August 11, 2020

**Re: Proposed Chase Bank – 1574 Woodbury Avenue - Site Plan Review**

**RE: Waiver Requests for Site Plan Review – 1574 Woodbury Avenue  
Proposed Chase Bank (at former Ruby Tuesday's)**

SHEET TITLE  
CONSTRUCTION DETAILS  
JOB #: JPM 27086  
DATE: 07/1/2020  
SCALE: AS NOTED  
DRAWN BY: MAL  
CHECKED BY: KGF  
**CD-5**

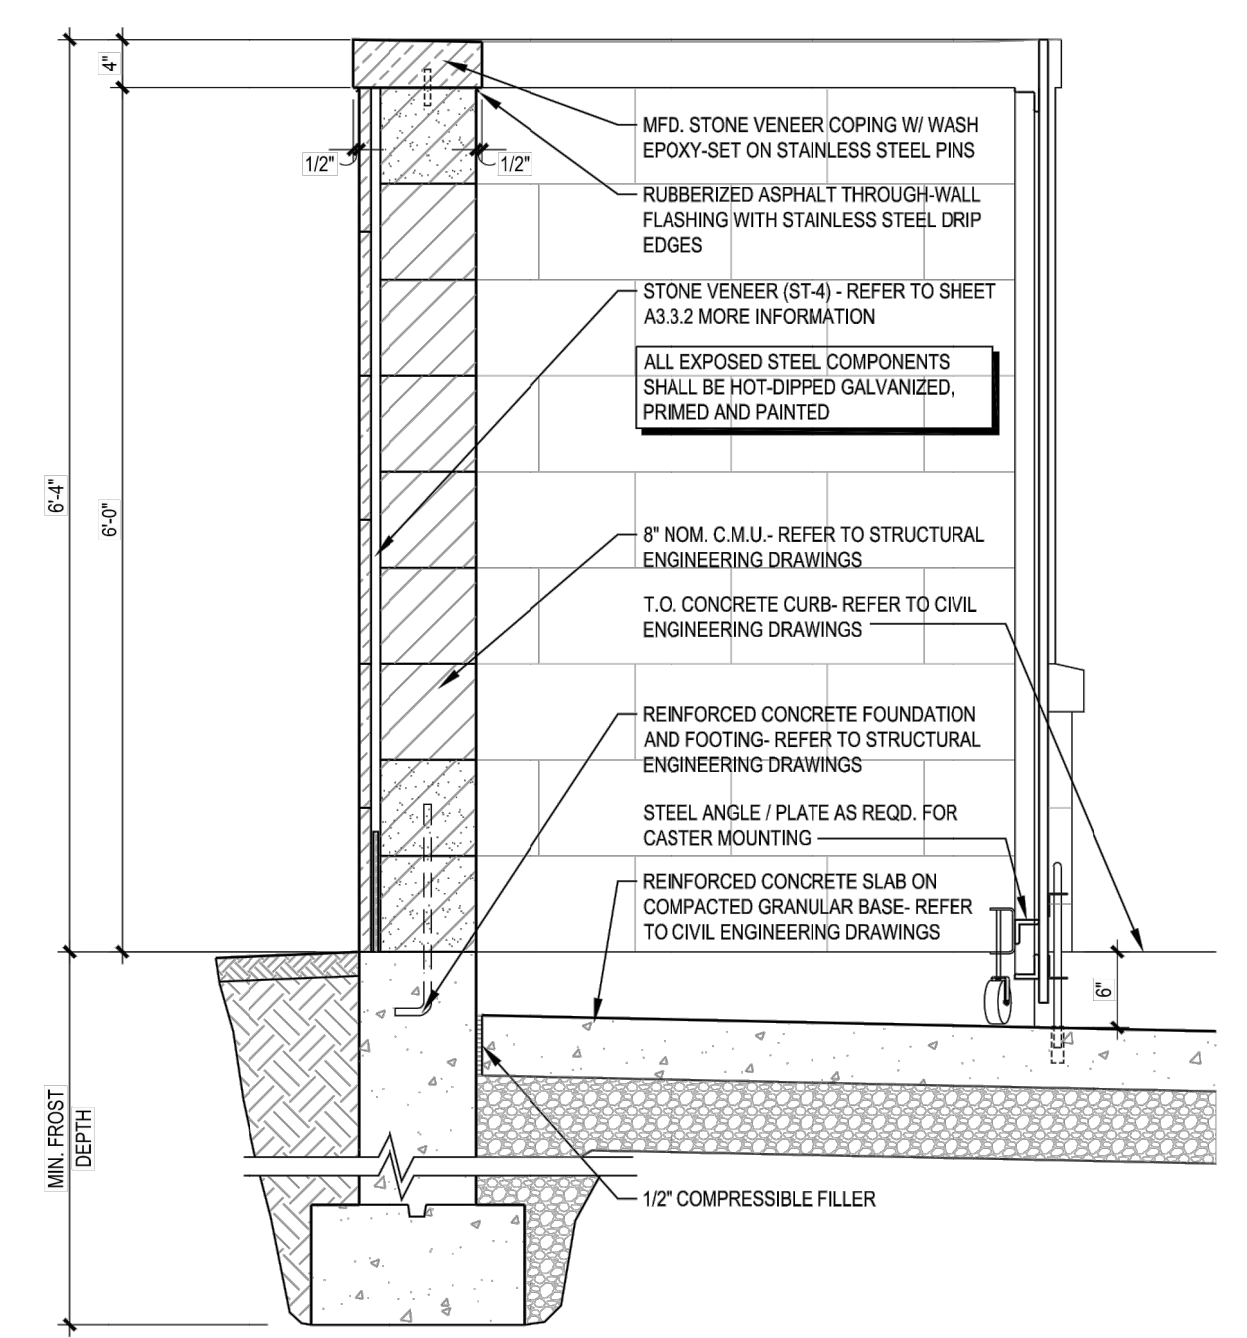
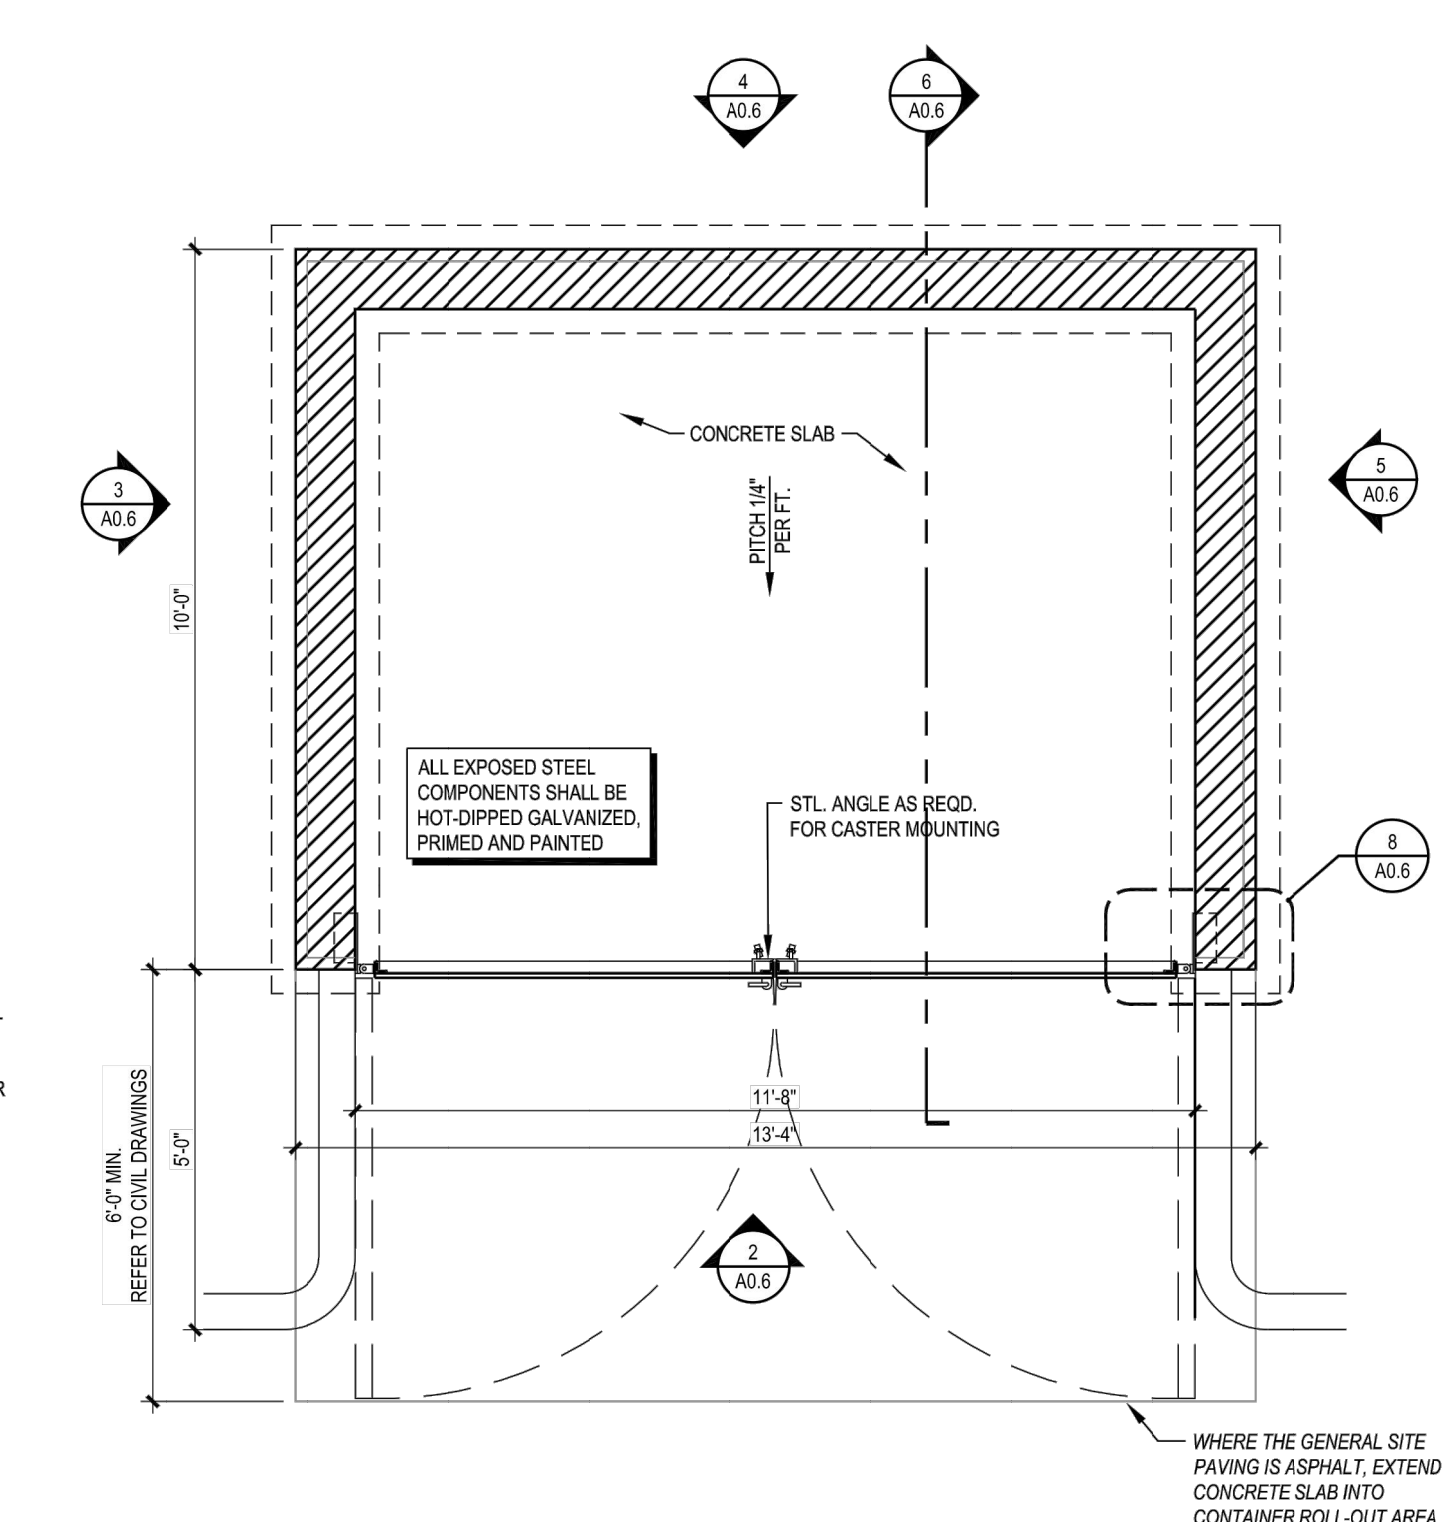
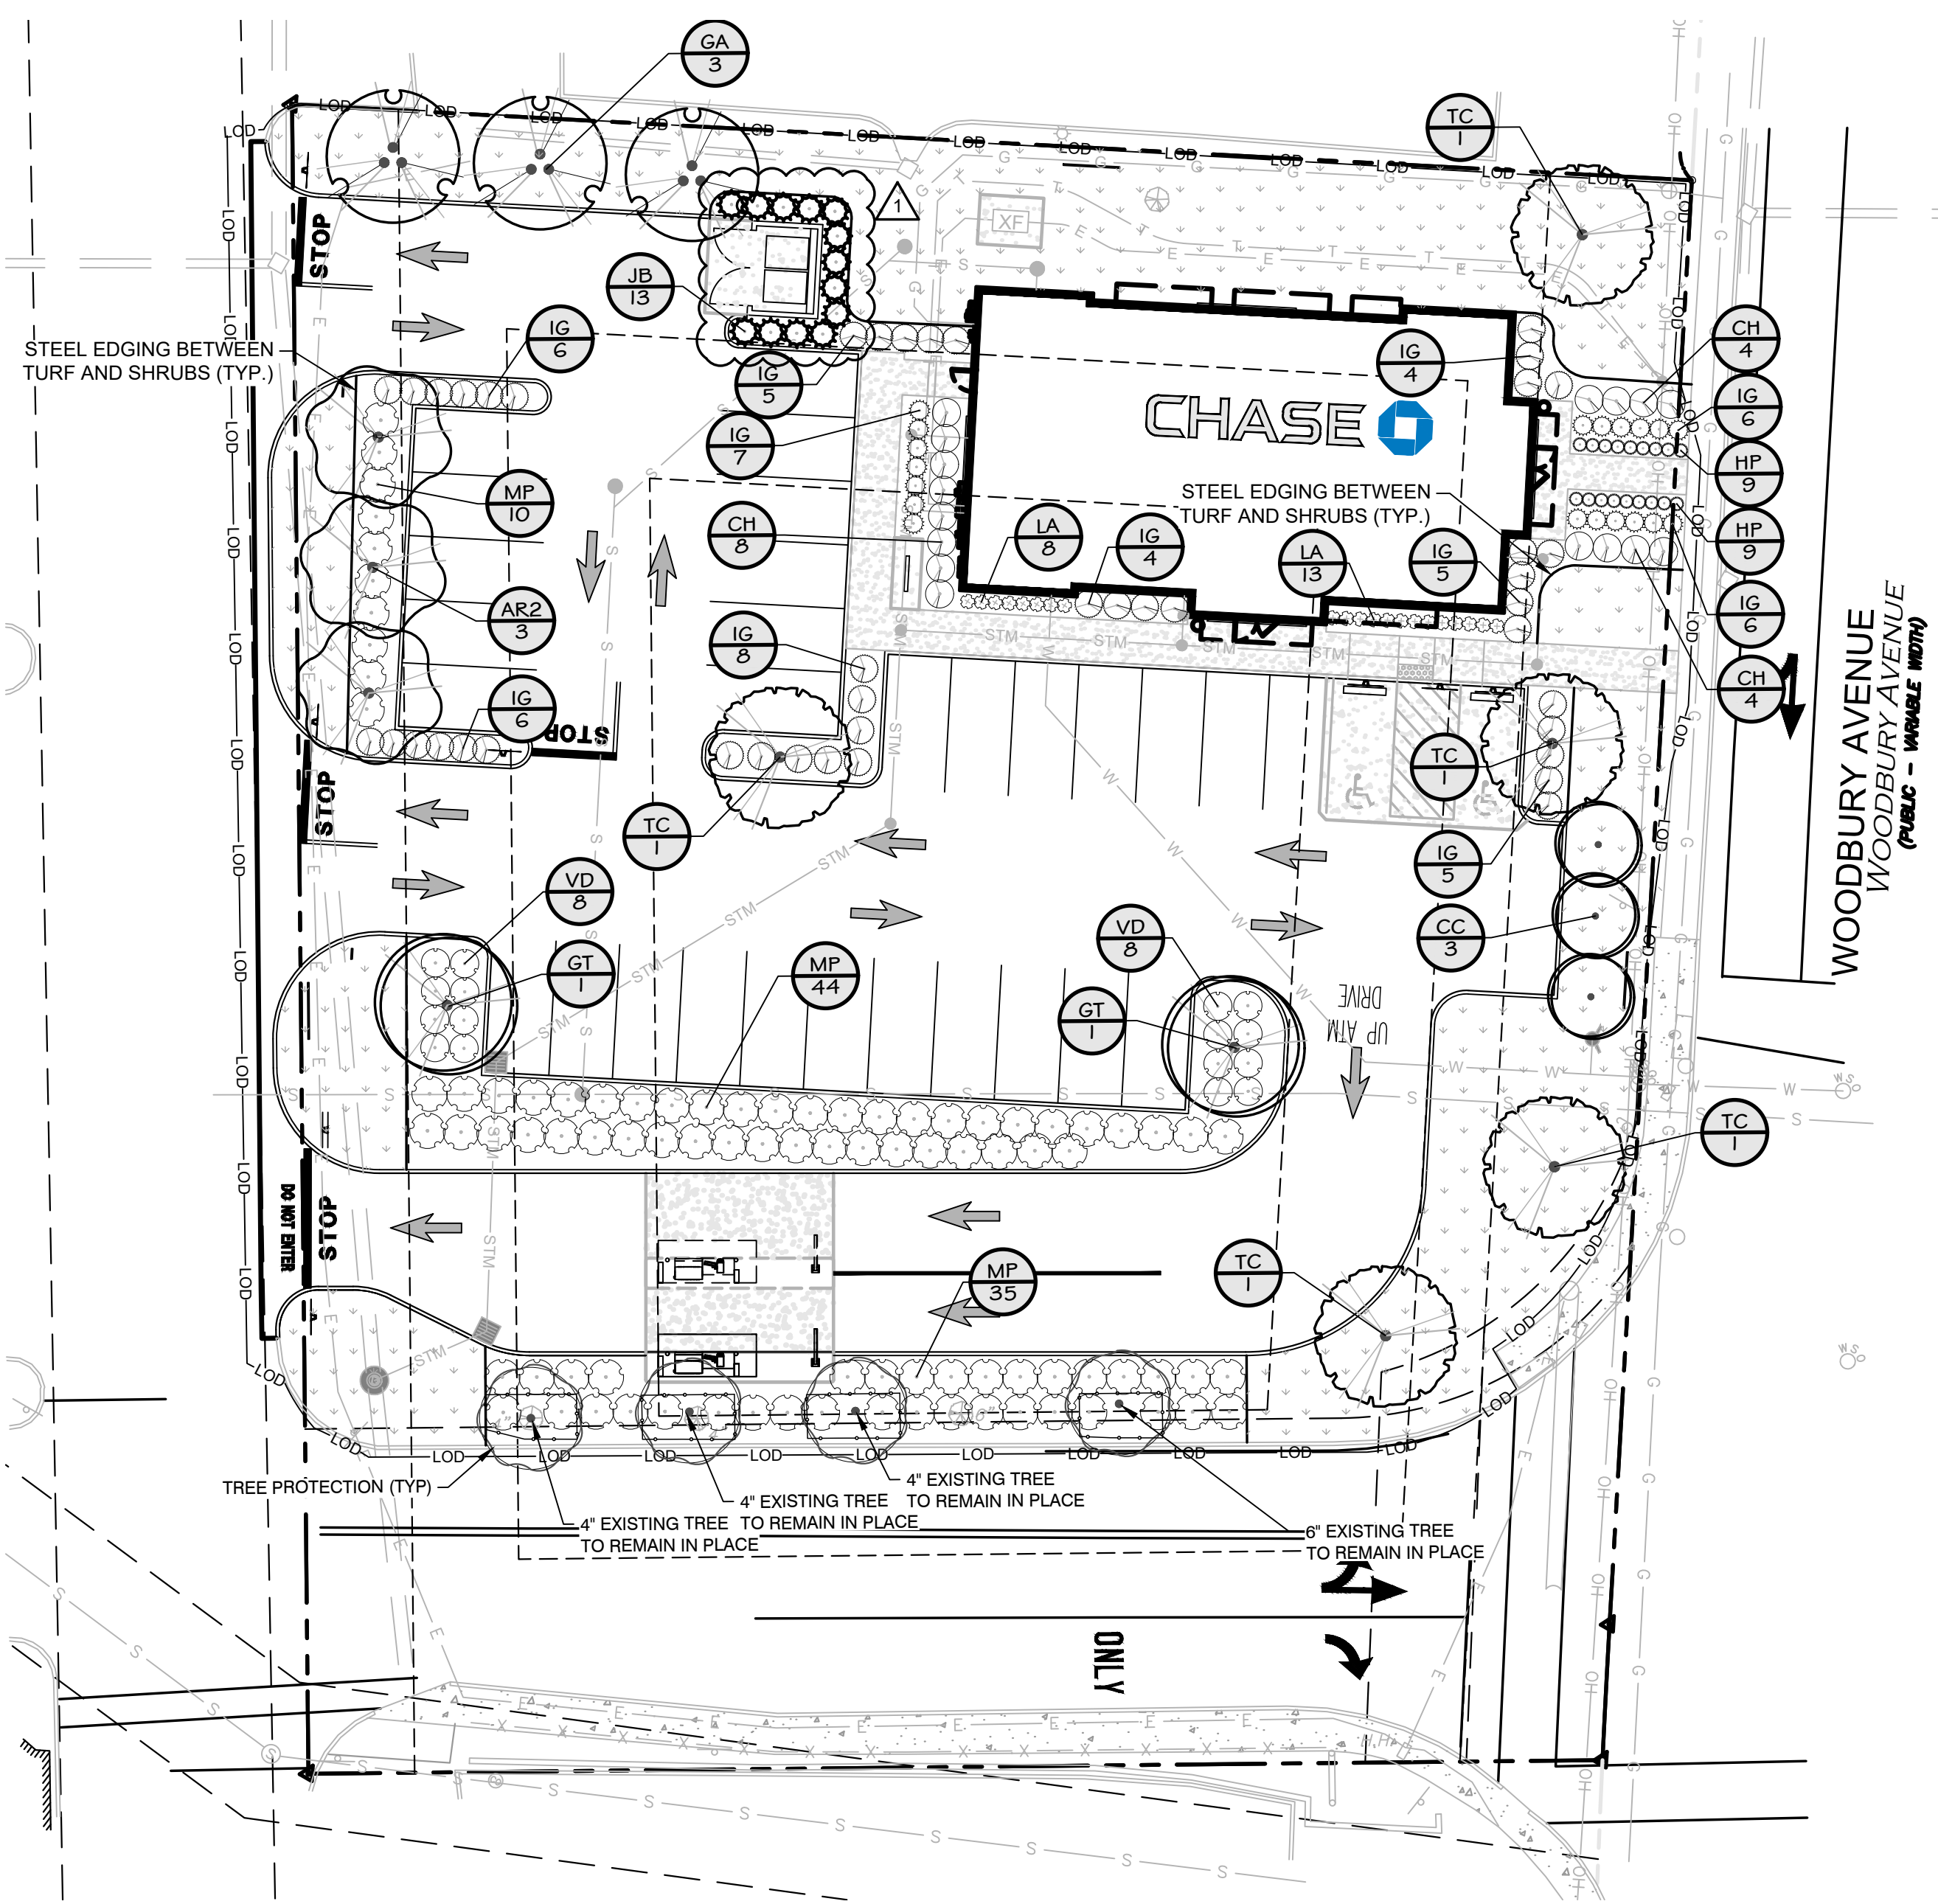
6. Please provide a detail of the dumpster screening consistent with the requirements of Section 10.1132 of the Zoning Ordinance  
*Added as requested. Please refer to drawing sheet CD-5.*
